1954 Corvette: Service Bulletin: Connecting Rods

Subject: Connecting Rods

Source: Chevrolet Technical Service Bulletin

Bulletin No: DR-164

**REWORKING 1953 POWERGLIDE ROD FOR
USE IN 1954 POWERGLIDE ENGINE**

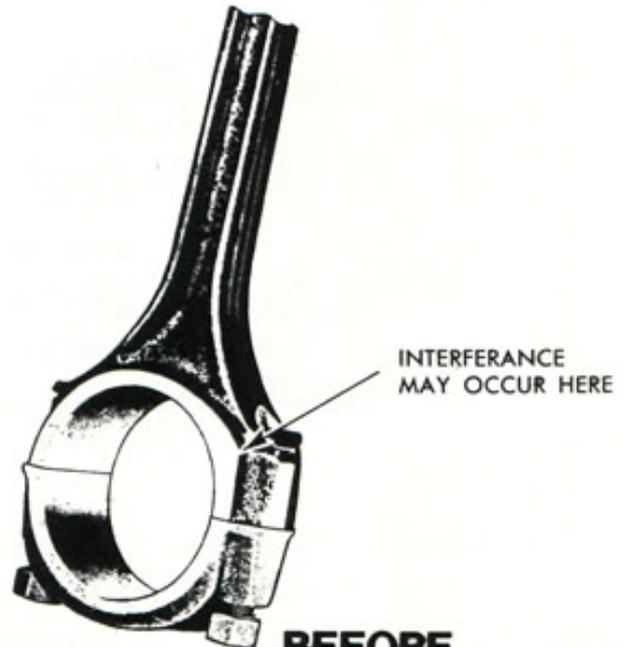
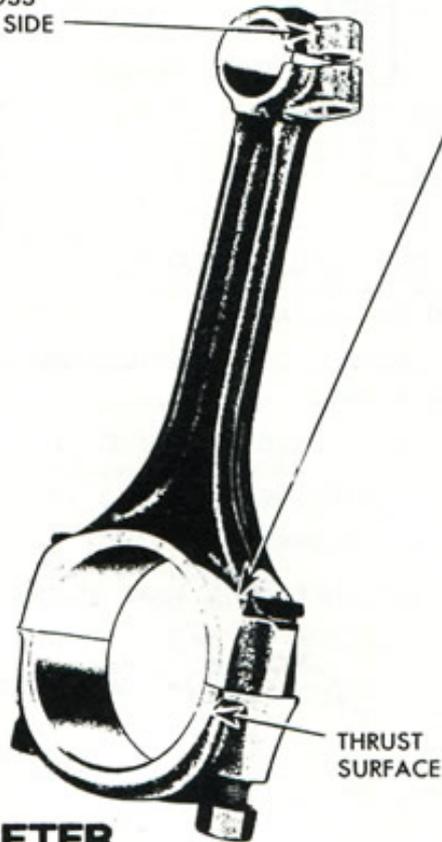
if the 1953 Rod is not reworked, interference may occur between the new wide lobed (9/16") camshaft and the number 2, 4 and 6 rods on the camshaft side at the rear of the rod in the area at top of connecting rod bolt.

PINCH BOLT BOSS
TO CAMSHAFT SIDE

RELIEVE THIS AREA
BY GRINDING AS SHOWN.
GROUND AREA SHOULD BE
AT 30° WITH THRUST SURFACE
OF ROD-CAMSHAFT SIDE-REAR
ON NO. 2, NO. 4, NO. 6 RODS

Until such time as the 1954 Passenger Car Powerglide Connecting Rods are available and it is necessary to replace a rod in a 1954 Powerglide Engine, the 1953 Powderglide Rod may be used after reworking.
